# OICA – Working-Group on *Ducting & Enclosure* for brake emission testing

28.09.2023

# Introduction of the Working-Group *Ducting & Enclosure*

# Inlet conditions - Airflow homogeneity at Plane C (CFD)

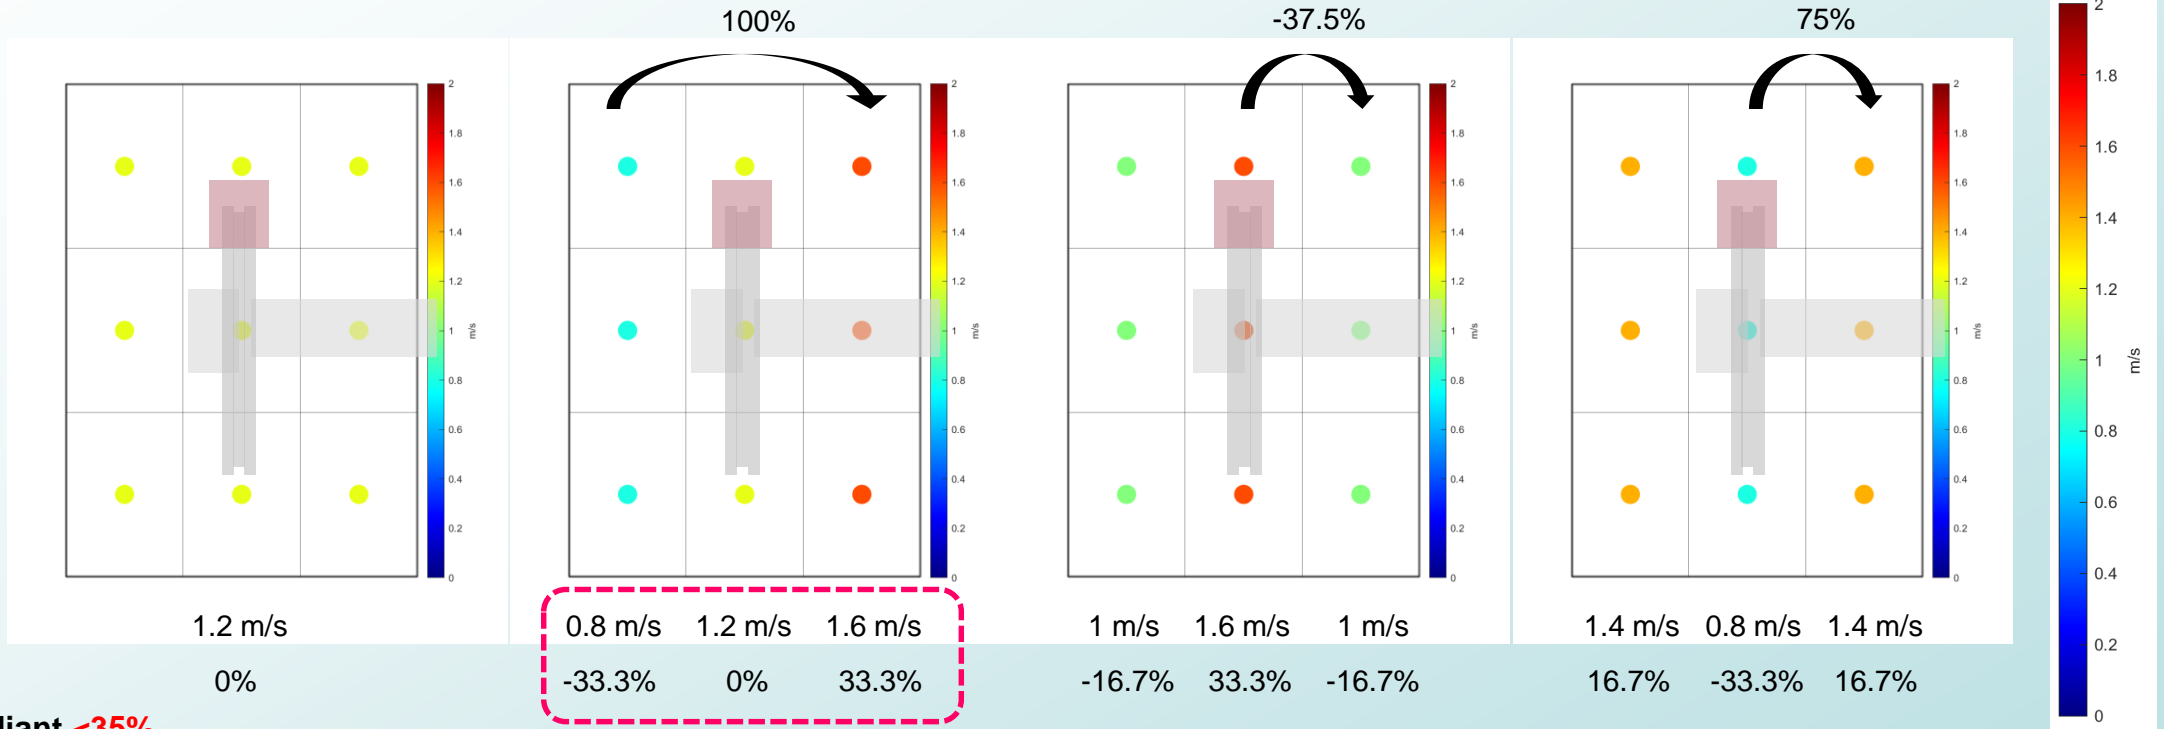
GTR-compliant <35%

Change in volume flux to achieve similar cooling (to 1.2 m/s in the middle section)

-25% to 1134 m<sup>3</sup>/h

50% to 2268 m<sup>3</sup>/h

Variation of volume flux between labs is not restricted to 35% (airflow homogeneity) for the same brake but could be much larger  
➤ tighter airflow homogeneity criterium

# Inlet conditions - Airflow homogeneity at Plane C (CFD)

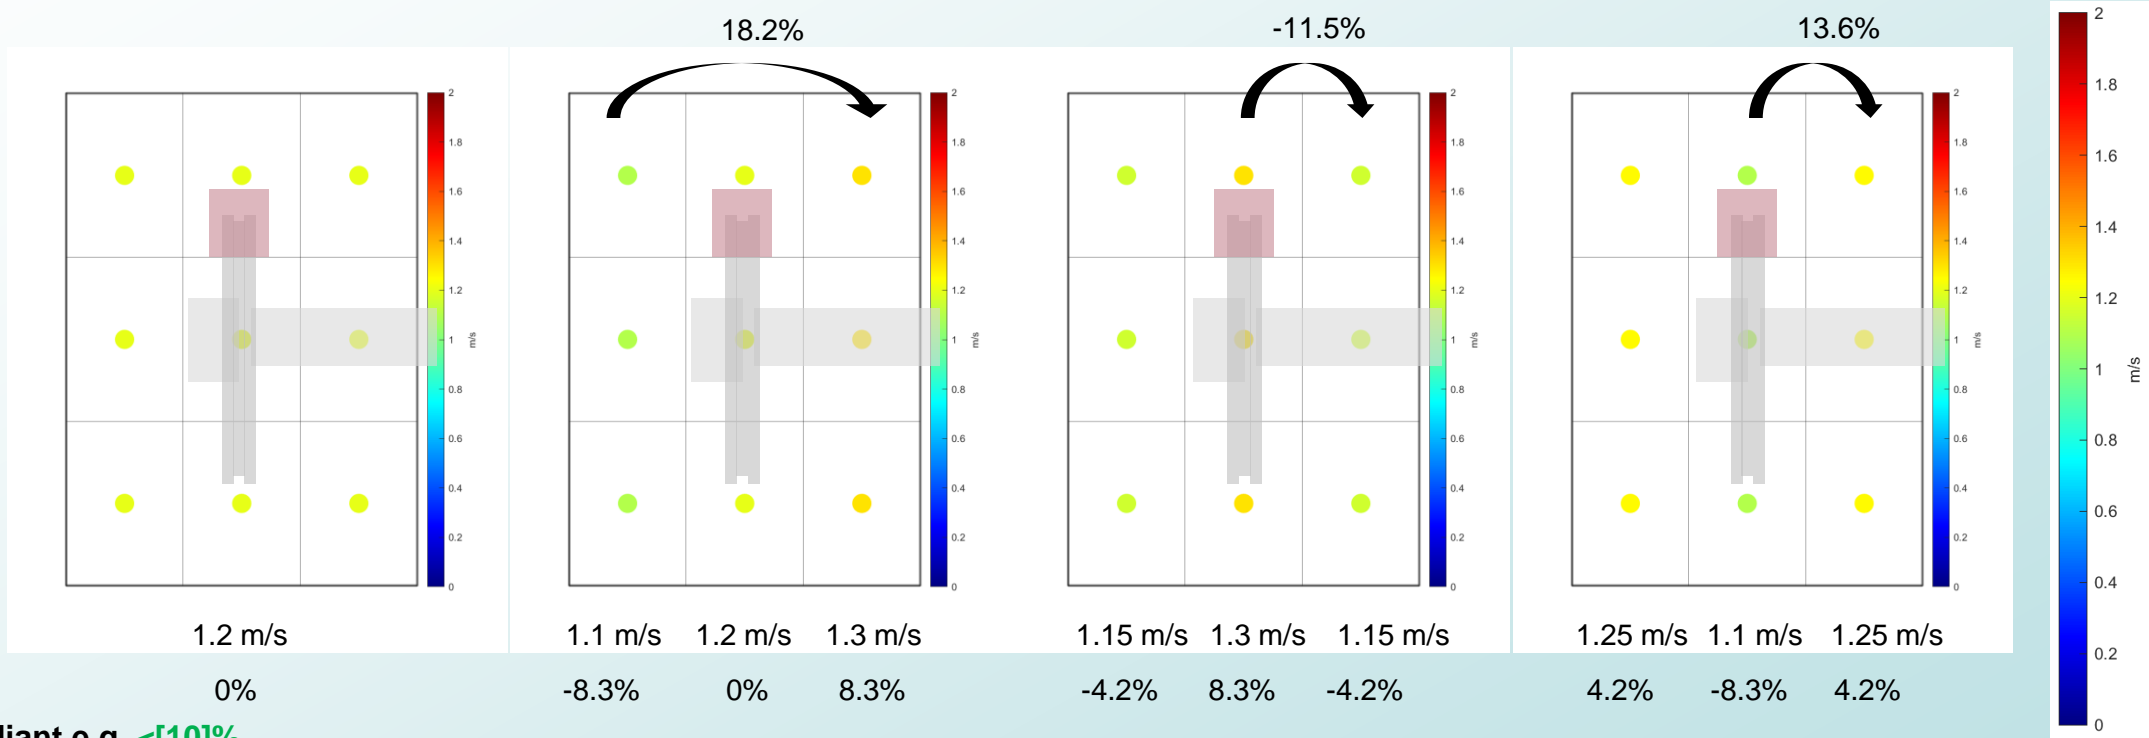
GTR-compliant e.g. <[10]%

-7.7% to 1396 m<sup>3</sup>/h

13.6% to 1717 m<sup>3</sup>/h

**Not only the airflow homogeneity criterium will be sufficient, enclosure dimensions and sampling ducting will still impact particle distribution and particle loss and need to be fixed**
